Report to the Planning Commission

DATE ISSUED: December 11, 2025 REPORT NO. PC-25-048

SUBJECT: 7951 PASEO DEL OCASO, Process Two Appeal

PROJECT NUMBER: PRJ-1133046

TOPOGRAPHIC SURVEY

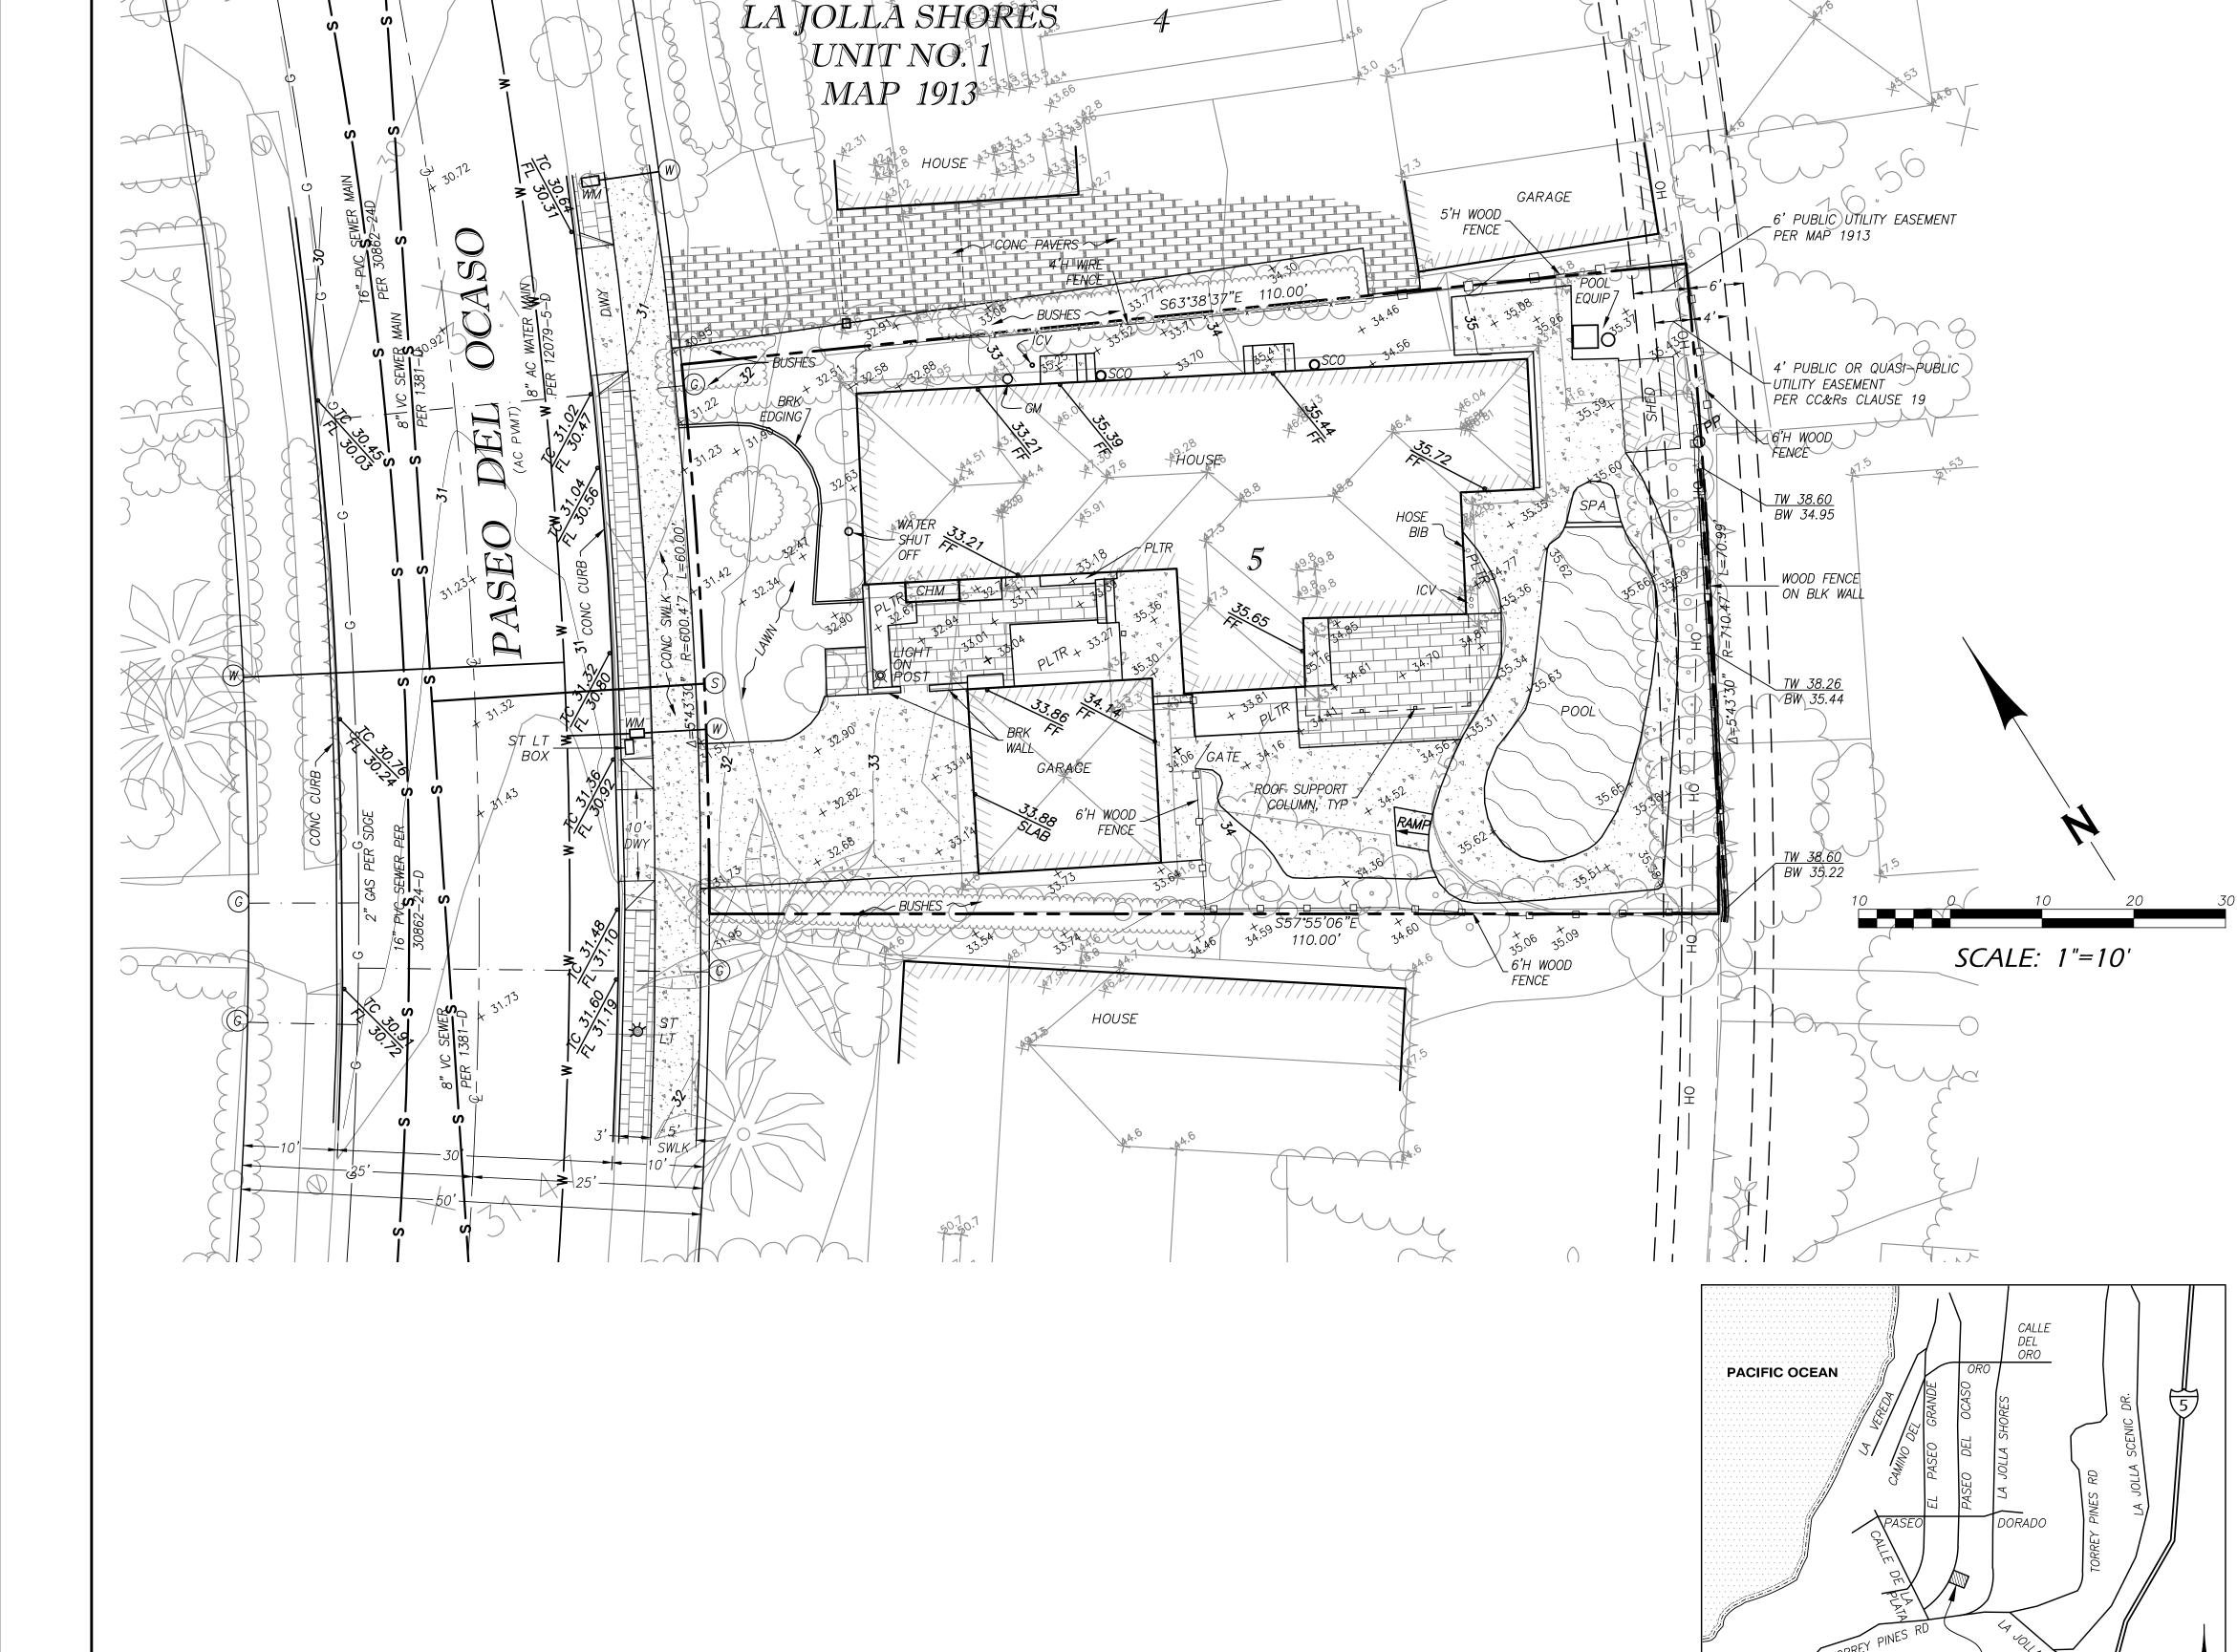
a) Because the new 2025 Baylor Plan hides the reference point established by the PP (Power Pole, see the attached Power Pole pdf, Attachment A-02), in order to claim that the 7944 La Jolla Shores Drive (Lot 19) retaining wall crosses the property line at the north end, even though it does not cross the property line.

Correct Topographic Survey, as Baylor Project is still using an erred 5 year old Coffey Engineering Survey (dated 2/19/19, *see note below), which is off by 2-3 feet in elevation in comparison to the recent (12/30/24, Attachment A-06) Lot 19 Survey (see the attached 4/23/25 Demand Letter with its Terwilliger Land Survey, Attachment A-07, the Three-Foot-Retaining-Wall-No-Slope "3 FT RW NO SLOPE.pdf", Attachment A-08, and "LOT 5 FAKE SLOPE.pdf" images, Attachment A-09, confirming this discrepancy,), for it is impossible to have such a big difference of up to 3 feet between the two surveys.

The project plans include a Topographic survey prepared by Coffey Engineering, dated 05/19/2025 (Sheet C.0 of the project plans, Attachment 07). The appellant relied on an older version of the project at 7951 Paseo Del Ocaso, which will be superseded by the plans approved under this Substantial Conformance Review (SCR).

The current survey shows the east property line through a utility pole between the two properties. The photograph provided in attachment A-02 is consistent with the survey and the proposed plans.

Staff has reviewed a Topographic survey prepared by Coffey Engineering, dated 05/19/2025 (Sheet C.0 of the project plans, Attachment 07). Engineering Review staff found no grade elevation discrepancies. The survey accurately reflects existing conditions, including the retaining wall and utility pole at the shared property line. This survey supports the approved building elevations and confirms conformance with applicable height and grading standards.

Staff has reviewed a Topographic survey prepared by Coffey Engineering, dated 05/19/20 (Sheet C.0 of the project plans, Attachment 07). The survey supports the vertical datum utilized to establish the overall building height. In addition, a Height Verification flag will be added to the construction permit application, which will be conducted by the Inspector and cannot be cleared until the height is verified. If a height issue is revealed through the Height Verification Process, the issue will need to be corrected, as a deviation of the 30-foot height limit is not permitted.

Annotated topographic survey from Coffey Engineering sheet C.0

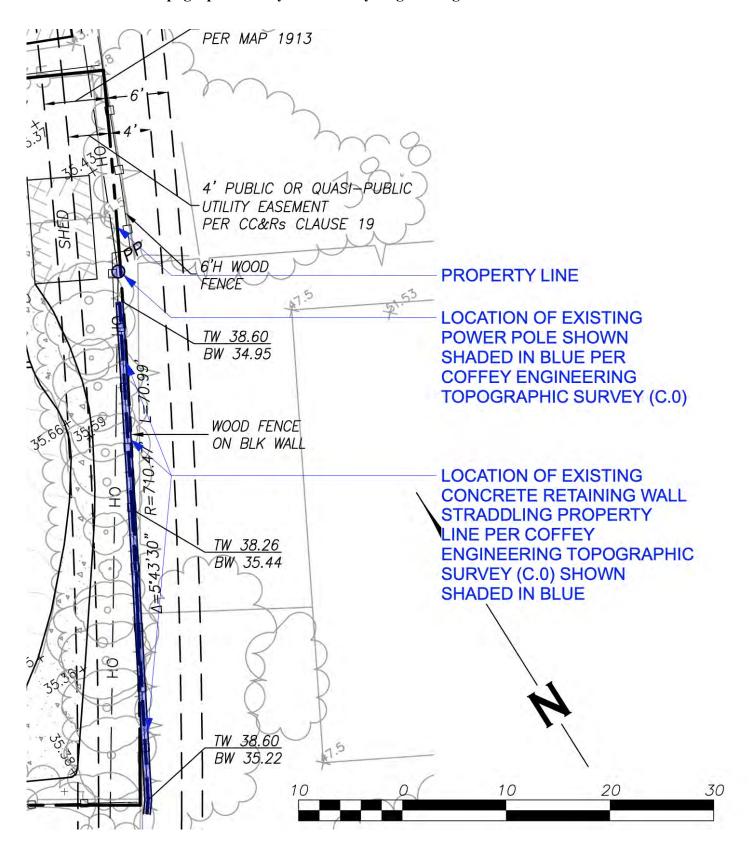
a) Because the new 2025 Baylor Plan for 7951 Paseo Del Ocaso (Lot 5) hides the reference point established by the PP (Power Pole, see the attached Power Pole pdf, Attachment 02), in order to claim that the 7944 La Jolla Shores Drive (Lot 19) retaining wall crosses the property line at the north end, even though it does not cross the property line.

b) Furthermore, the Baylor Project still has not provided the official Corner Record or the Property Survey and has not staked out its property lines, which is not acceptable for a project of this magnitude.

The retaining wall in question is shown on the permit plans as an existing feature that is to remain. No new work is proposed along or beyond the shared property line. The permit application includes a topographic survey (Sheet C.0) prepared by Coffey Engineering, which depicts the property line running through an existing utility pole between the two properties. The same survey indicates the retaining wall is located near this shared line.

As demonstrated in the submitted topographic survey prepared by Coffey Engineering (Sheet C.0), the property lines and existing features—specifically the retaining wall and utility pole—have been clearly documented and correspond with the appellant's own photographic evidence and Corner Record reference.

Grading Tabulation from Coffey Engineering Sheet C.3

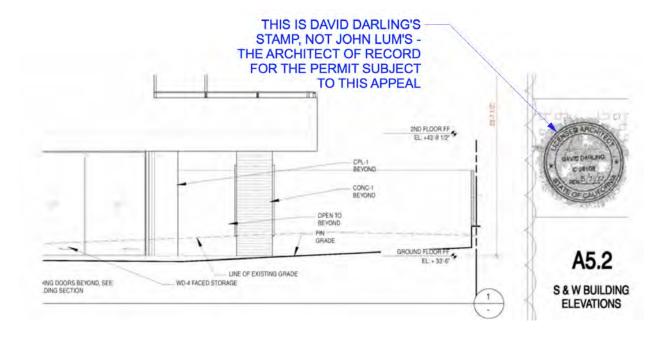
- These discrepancies cast significant doubt on the reliability of the Terwilliger survey.
 - 3. The Grading Permit for La Jolla Shores Planned District, because 2025 Baylor Plan continues to show a 3-foot slope from the 33.5-foot grade (see the LINE OF EXISTING GRADE pointer in the "LOT 5 FAKE SLOPE.pdf" taken from page A5.2 of Baylor Project dated 6/19/22, Attachment 09), though there's no slope (which is confirmed by the attached images, "3 FT RW NO SLOPE.pdf", Attachment 08, and the Terwilliger Land Survey, Attachment 06, showing that the existing grade of Lot 5 at the swimming pool and the retaining wall is already at 33.5', so it would be absurd to dig 3 feet into an existing grade of 33.5' to achieve 33.5' grade, unless the plan is to add 3 feet of dirt in the back of the building creating a +3 foot elevation increase).

- The approved project does not trigger the threshold for a Grading Permit. As shown in the Grading and Drainage Plan (Sheet C.3) and Topographic Survey (Sheet C.0) prepared by Coffey Engineering, the proposed work involves limited cut and fill volumes with mild slopes. These conditions fall well below the thresholds that require a grading permit under the City of San Diego Municipal Code.

"Lot 5 Fake Slope" pdf from Appellant, marked up by the applicant.

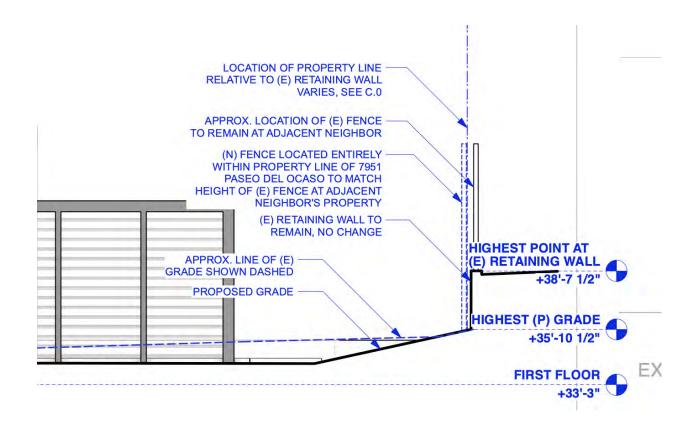
Therefore, this 3-foot slope (see LINE OF EXISTING GRADE pointer) misinformation, may lead to an "unintentional" augment of the existing 33.5' grade during addition of fill dirt to the old swimming pool. In effect, a new grade will be created at 36.5', ready for future 30 foot building upgrade at the Lots' 5.49 property line to an increased height of the building from the current 33.5' + 20' = 53.5' to 53.5' + 10' = 63.5' plus the "imaginary", but fully documented, slope of 3 feet = 66.5' feet, just like had been planned by the Baylor Project 2 years ago (see page A5.2 of Baylor Project dated 6/19/22, ** Attachment 11).

- The appellant's comments referencing 3 feet of excavation and fill appear to be based on their own assumptions rather than actual data. For authoritative grading parameters, we defer to the Grading Tabulations on Sheet C.3, which have been prepared and certified by a licensed civil engineer. The appellant's interpretations, including hand-drawn spot elevation estimates, lack evidentiary value and do not represent standard civil or planning practice.

Excerpt from Coffey Engineering Topographic survey with existing spot elevations at the rear of the property highlighted by the applicant.

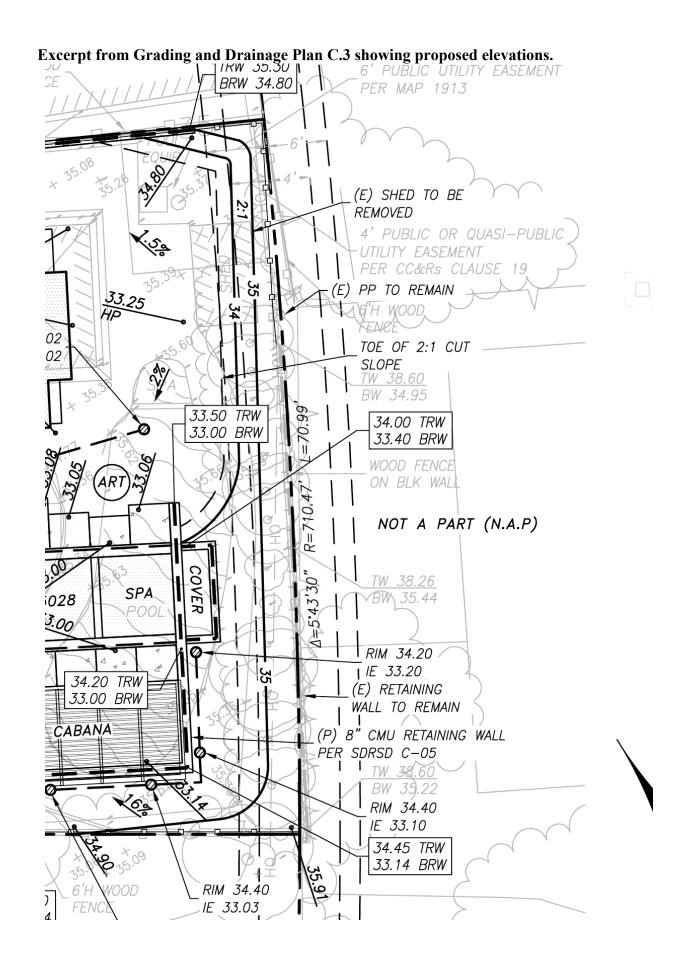
The appellant's claim that the project is based on an "erred" 2019 survey is factually incorrect. The approved plans are based on a 2025 topographic survey prepared by Coffey Engineering (Sheet C.0), which accurately reflects existing conditions, including the retaining wall and utility pole at the shared property line. This survey supports the approved building elevations and confirms conformance with applicable height and grading standards. The Appellant appears unfamiliar with topographic survey reference points and confuses data from different official vertical control benchmarks as errors.

Excerpt from Approved Substantial Conformance Review exhibit sheet A3.02 showing proposed design with outline of previously approved design by former architect Aidlin Darling Design shown dashed in blue.

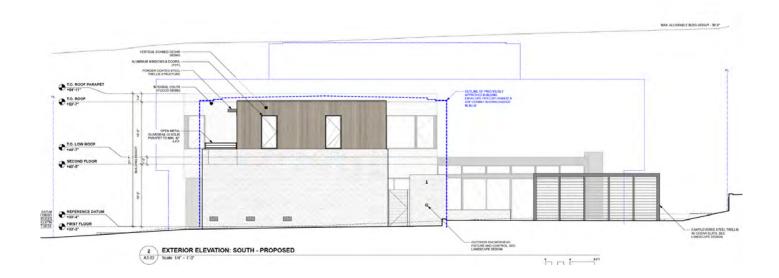
4. <u>Concluding Comment</u>: If Baylor Project refuses to produce a corrected Topographic Survey, the Grading Permit and a Corner Record, Attachment 03, in order to prevent future building height and retaining wall location litigation (Baylor's new drawings still show that Lot's 19 retaining wall encroaches Lot 5 by the Power Pole, and is less than the actual 8 inches from Lot 5 at the south end), I hereby request DSD to use the Power Pole (which was placed on the property line, see Power Pole.pdf, Attachment 02), as a reference marker, and to have 20 feet marked on it above the current proposed project grade of 33.5 feet (or 33.5+20-36.17= 17.3 feet above the retaining wall of Lot 19 at 36.17'), and the secondary marker at 30 feet above the current grade (or 33.5+30-36.17= 27.3 feet from top of the Lot 19 retaining wall at 36.17'near the PP), Attachment 05.

Lum Architecture, which is the subject of this appeal. As documented on Sheet A3.02 (Detail 2), the approved building height is 21'-7," which is significantly below both the 30' height limit and the previous design's profile.
